Units 2 and 6, Reading Retail Park, Reading

CT UK Property Authorised Investment Fund
Technical Note: Pedestrian Infrastructure & Servicing Arrangements
August 2023

Appendix A: RBC Consultation Response – November 2022	
Appendix B: RBC Consultation Response – April 2023	
Appendix C: RBC Consultation Response – August 2023	
Appendix D: Revised Proposed Site Layout Plan	
Appendix E: Reading Retail Park Pedestrian Footway Photos – August 2023	
Appendix F: Swept Path Analysis Drawings – Servicing & Delivery (Foodstore)

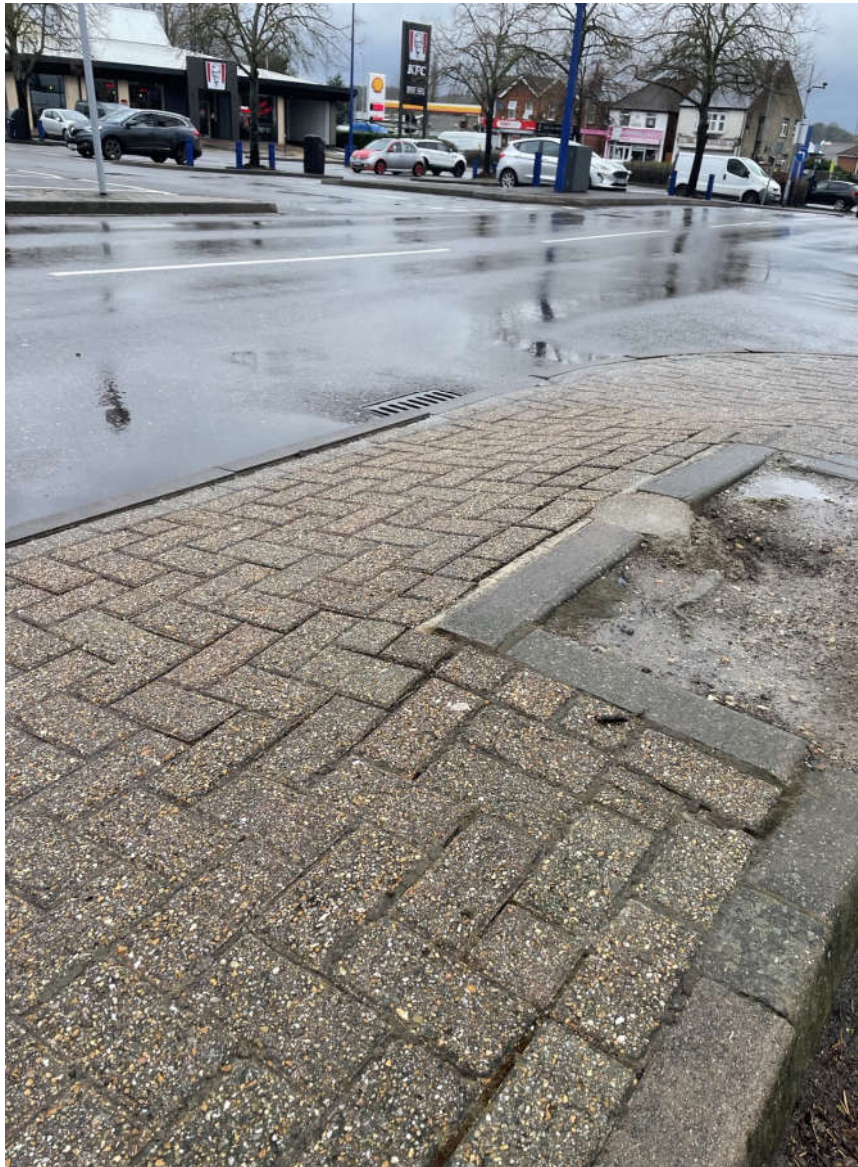
Subsequent, to the Highway Authorities initial comments it is noted that the crossing point within the existing car park along the pedestrian route to the store has now been provided with any tactile paving however as previously stated the width of the footway significantly reduces at the area where pedestrians would be required to cross. See image below for reference.

01 PROPOSED SITE PLAN
1:500

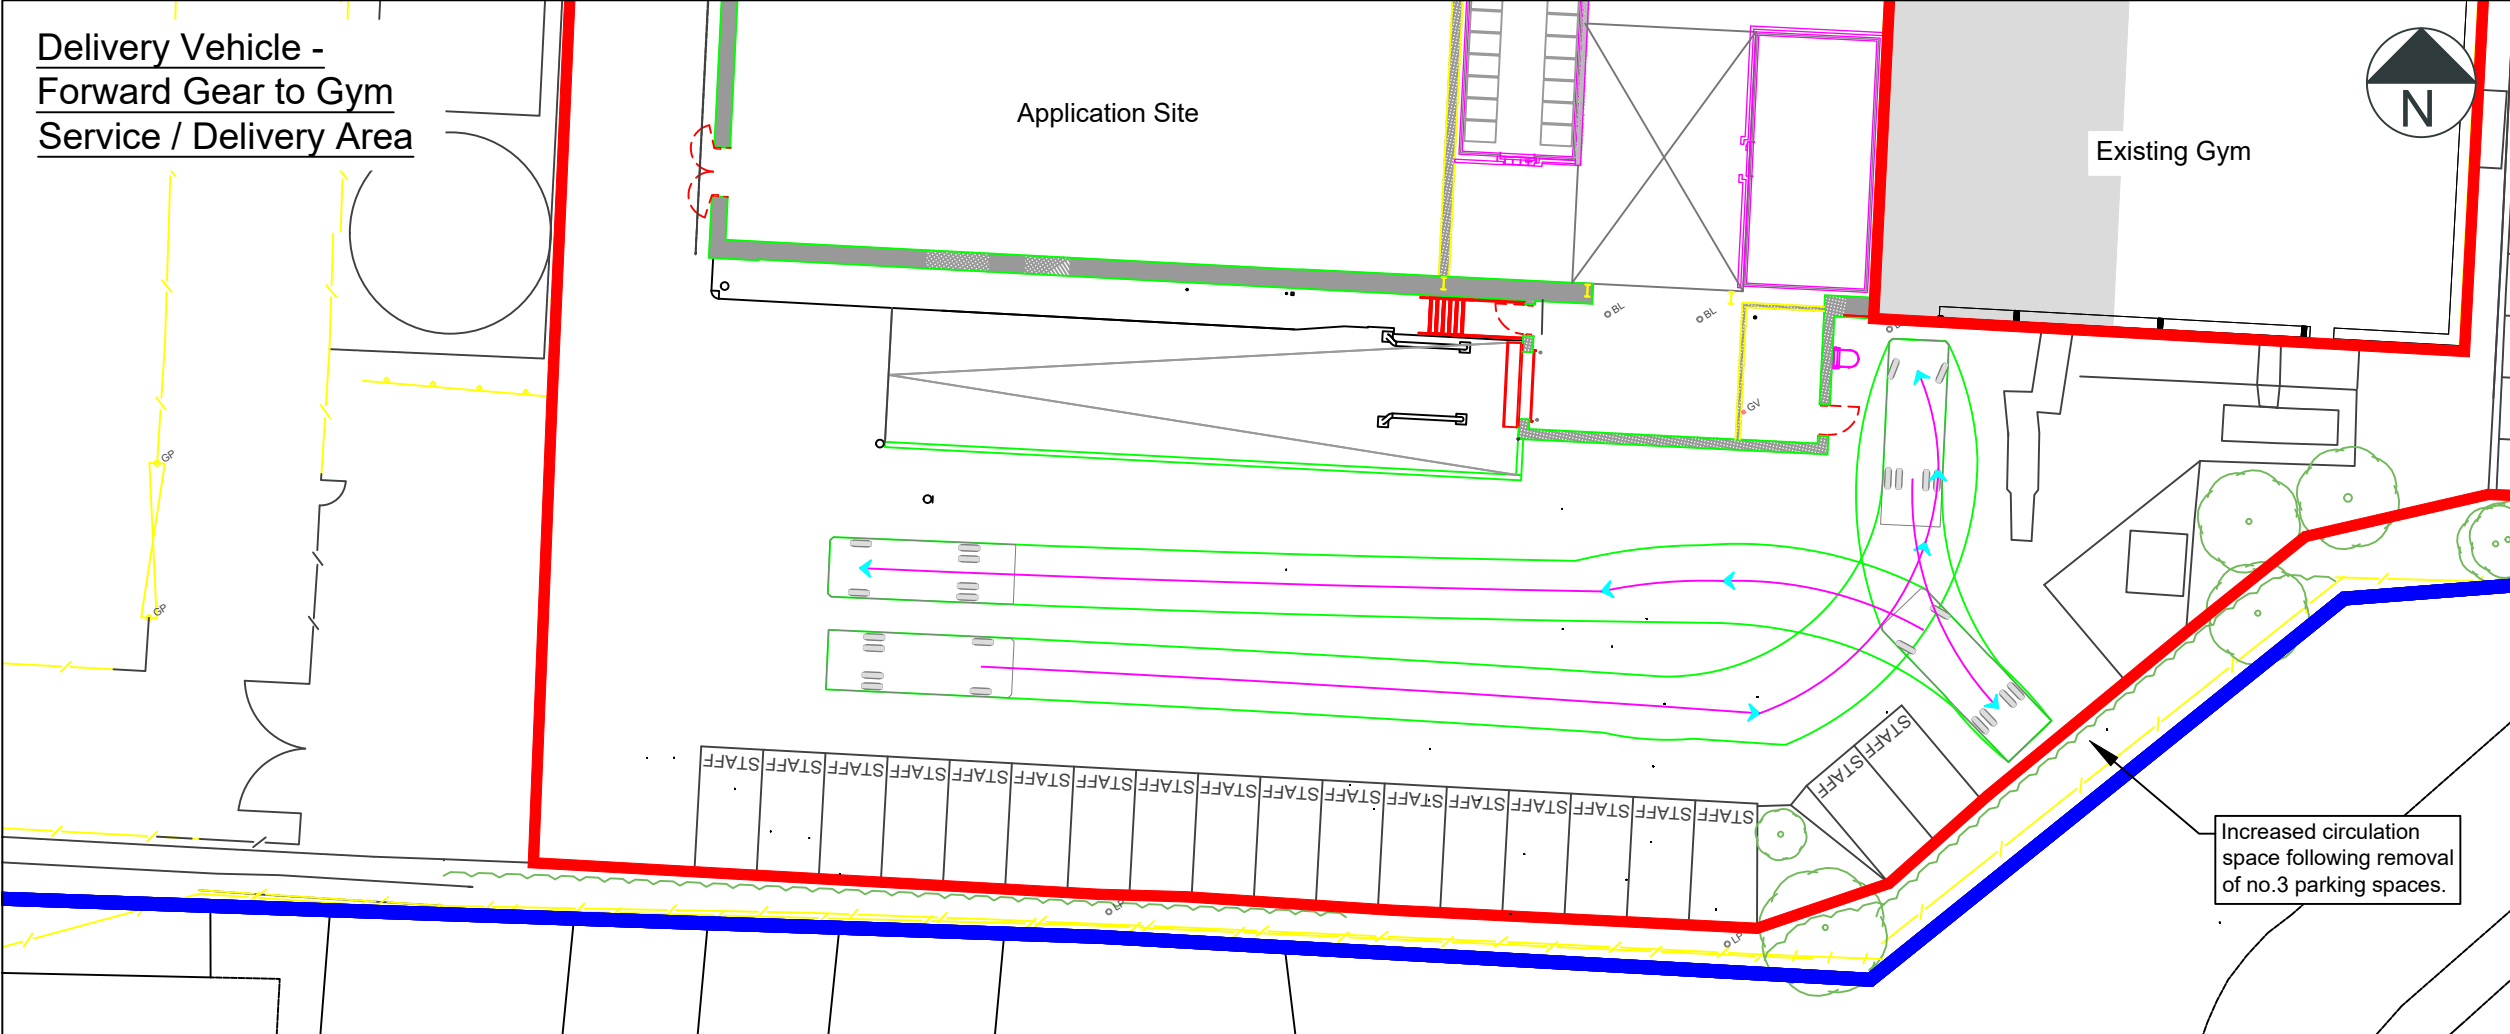
“These are significant increases [in forecast pedestrian trips] and as such the development will be required to make improvements to the internal pedestrian network by way of reduced upstands to dropped kerbs and widening of the footway around the crossing points. It is appreciated that standards do allow for reductions in footway widths but the narrowing’s should not take place at crossing facilities that would prove difficult for those with disabilities, buggies etc to navigate. The NPPF clearly states that pedestrian and cycle movements must be given first priority and as such the pedestrian facilities must be improved.

- The Highway Authority does not agree with the assessment that improvements made prior to the application mitigate the impacts of the development especially as the improvements have not provided facilities that are to the required standards. I would also advise that the two applications referenced within the attached only relate to associated tree works and do not provide any details of works surrounding the trees and as such they have not been party to any formal approval process. The Saturday assessment results in an increase of 91 pedestrian trips in the Peak hour and it is noted that across the whole day this equates to an additional 610 pedestrian movements. The daily weekday increase equates to 267.

- 2.2 In response to the above, the applicant is willing to commit to a Grampian Condition that ensures upgrades are made to the infrastructure – in the form of localised widening at the crossing point and resurfacing / levelling on approach to the application site – to provide a safe and suitable internal layout that does not prejudice the permeability of the application site by all pedestrians, including those visually or mobility impaired.

“No part of the development hereby approved shall be occupied until the pedestrian improvements as shown on Proposed Site Plan (15044-1-108) are implemented in full and retained in perpetuity with the approved development.

PROPOSED NEW PEDESTRIAN CROSSING. EXISTING KERBS MODIFIED TO ALLOW FOR DROPPED KERBS AND TACTILE PAVING.

Delivery Vehicle -
Forward Gear to Gym
Service / Delivery Area

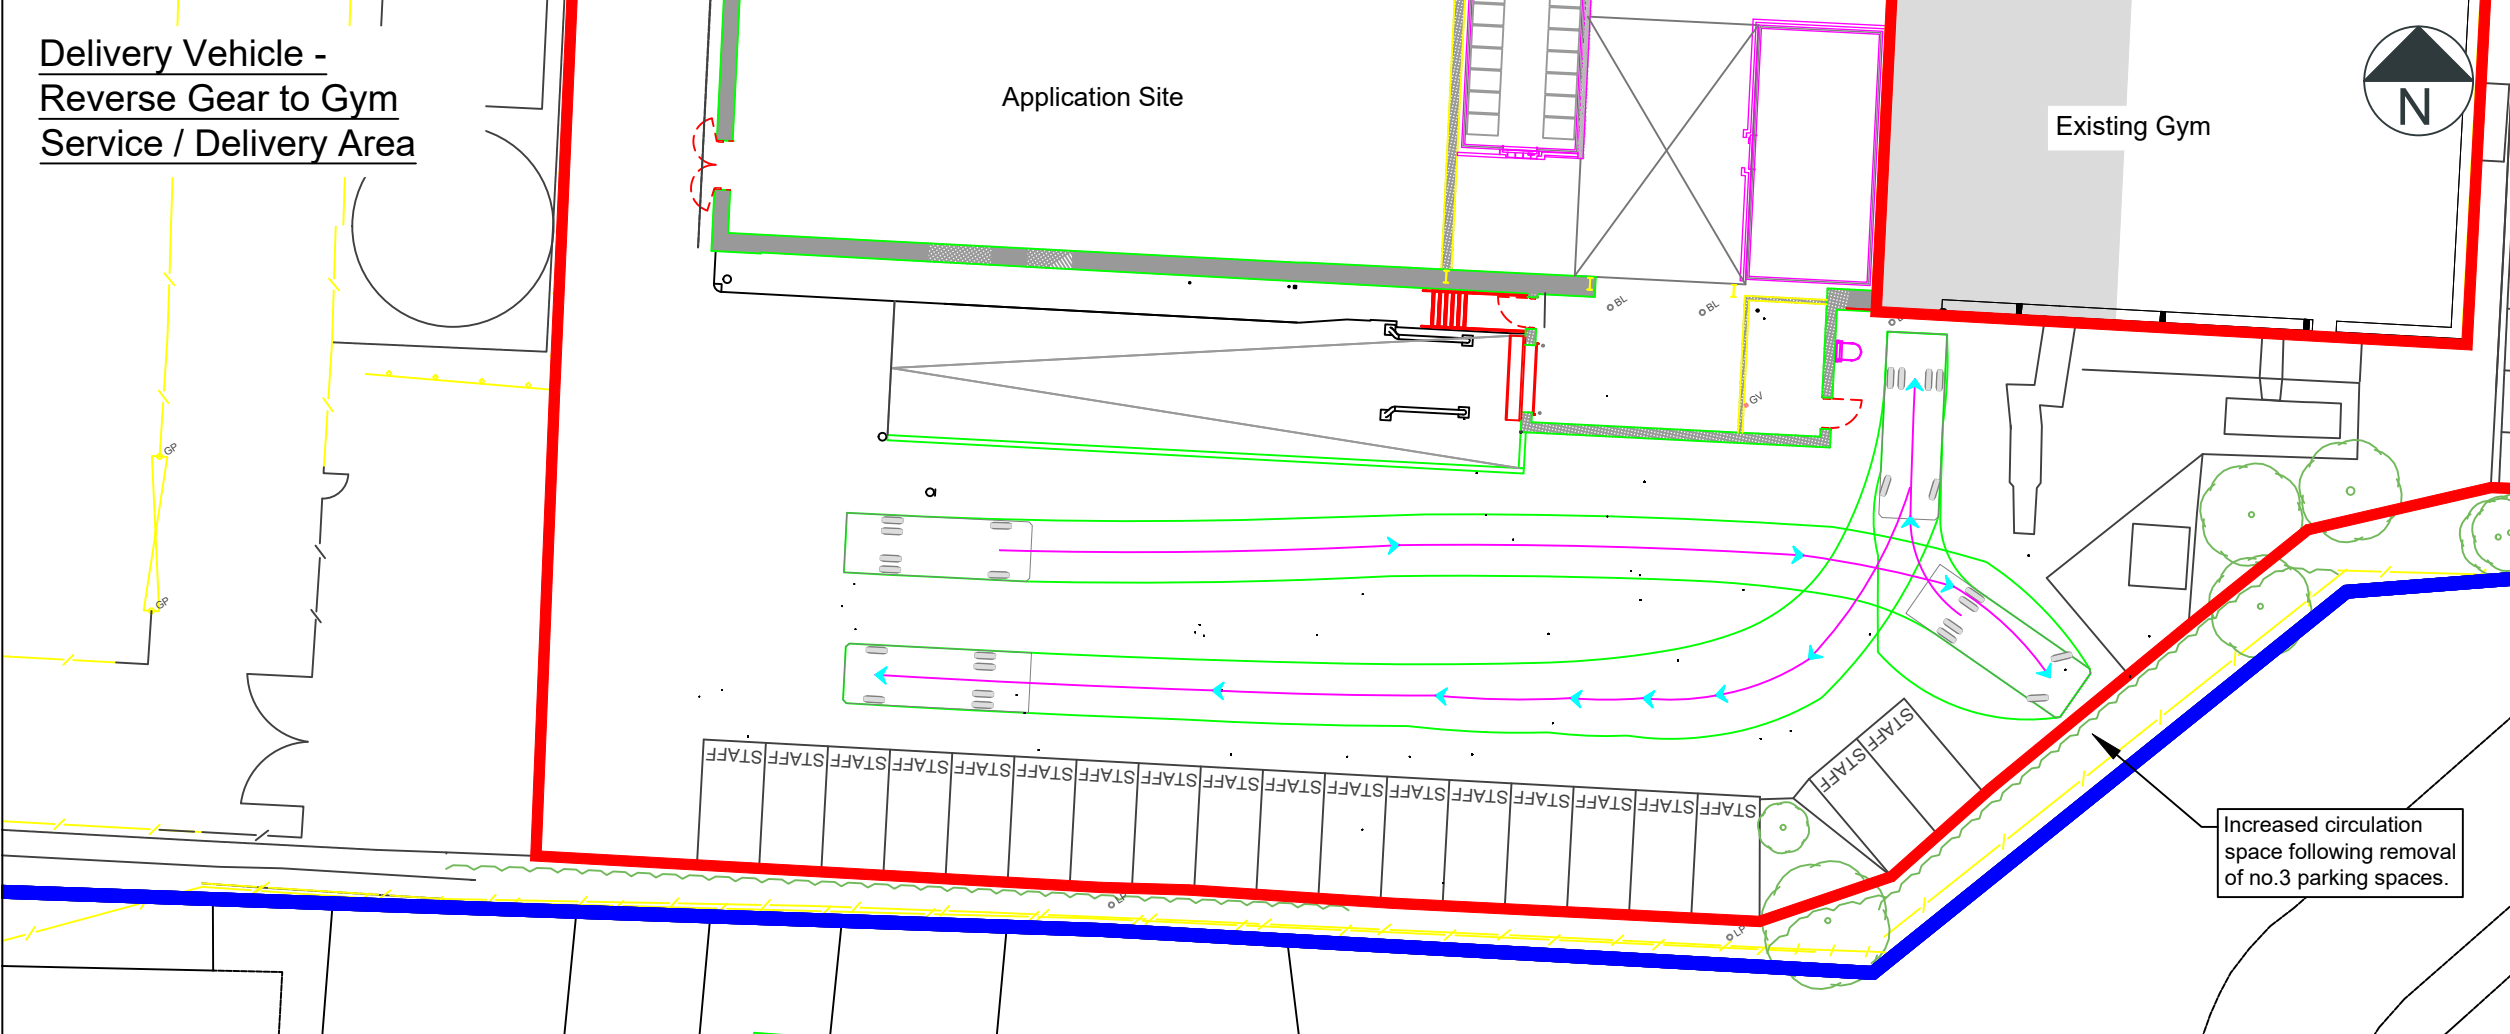
"The submitted document does not outline the servicing arrangements for the adjacent gym and therefore this must be provided."

As previously stated the changes to the rear servicing area signify a considerable change to the servicing of not only the proposed unit but also the retained gym located adjacent. The applicant has however failed to provide any detail on the servicing for this use. Further information is therefore required illustrating the tracking for service vehicles for this unit entering and leaving the service yard in forward gear without interrupting any other units.

- 2.8 Notwithstanding the above, and in order to provide a robust assessment that accounts for a future occupant with different arrangements, swept path analysis of the rear service yard has been undertaken to demonstrate that deliveries can be made to the rear of the unit, should they be required. The assessment illustrates that delivery vehicles are able to perform all necessary internal manoeuvres in a safe and suitable manner.
